ORIGINATION FORM

Proposed Revisions to a Standard Plans Index

Index Number: 400-011

Index Title: Gravity Wall

GENERAL NOTES

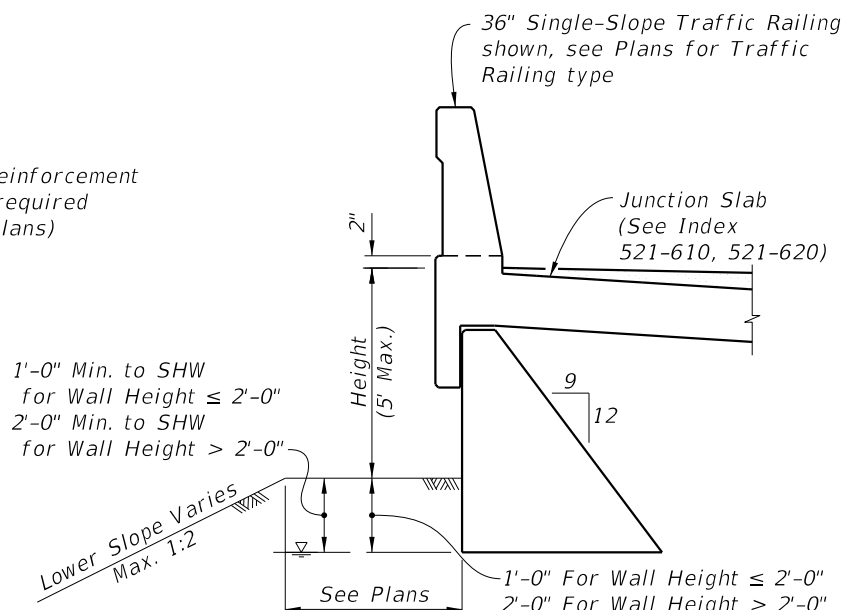
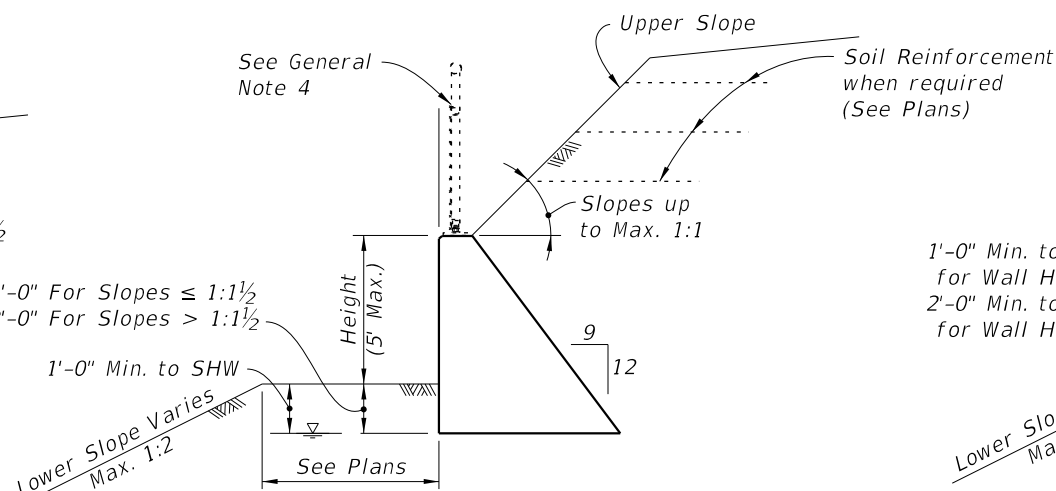
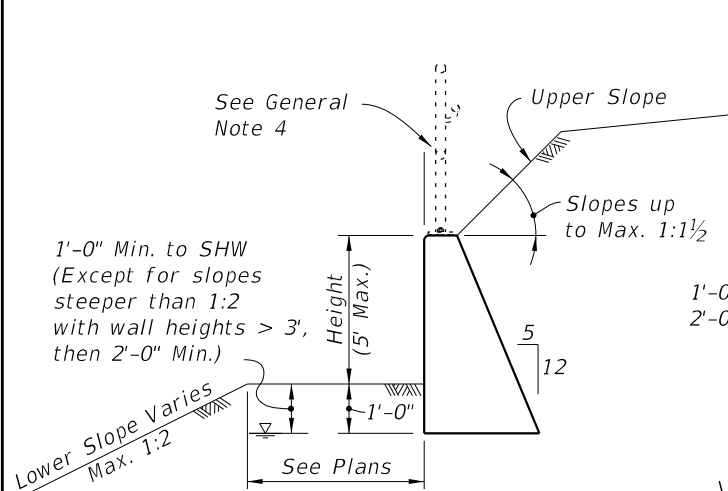
UPDATED: Joint Seal: Provide and install organic bond breaker or Type D-5 geotextile in accordance with Specifications 400 and 514, respectively.

- When required, for adjunct guiderail, see Index 515-070 or 515-080 as appropriate. For adjunct Type B fence see Index 550-002.
- Joint Seal: Organic Felt bond breaker in accordance with Specification Section 400 or Type D-5 geotextile fabric in accordance with Specification Section 985. Mop all contact surfaces of concrete and Organic Felt or geotextile fabric with cut-back asphalt. Stop Organic Felt or geotextile fabric 6" below top of wall.

- Provide a continuous 1'x1' clean gravel or crushed rock drain for wall heights 3 ft. and higher. Wrap drainage layer as shown, with Type D-3 geotextile fabric in accordance with Specification Section 985. Provide 8"x8" galvanized mesh with 1/4" openings, at the inside end of the PVC Drain Pipe. Provide 2" Ø PVC Drain Pipe (Sch. 40) at 10 ft. max. spacing (when Drainage Layer is required). Locate outermost edge of Drain Pipe a minimum of 2'-0" from wall joints.

- When required, for adjunct guiderail, see Index 515-070 or 515-080 as appropriate. For adjunct Type B fence see Index 550-002.
- Joint Seal: Provide and install organic bond breaker or Type D-5 geotextile in accordance with Specifications 400 and 514 respectively. Mop all contact surfaces of concrete and Organic Felt or geotextile with cut-back asphalt. Stop Organic Felt or geotextile 6" below top of wall.

- Provide a continuous 1'x1' clean gravel or crushed rock drain for wall heights 3 ft. and higher. Wrap drainage layer as shown, with Type D-3 geotextile in accordance with Specification 514. Provide 8"x8" galvanized mesh with 1/4" openings, at the inside end of the PVC Drain Pipe. Provide 2" Ø PVC Drain Pipe (Sch. 40) at 10 ft. max. spacing (when Drainage Layer is required). Locate outermost edge of Drain Pipe a minimum of 2'-0" from wall joints.
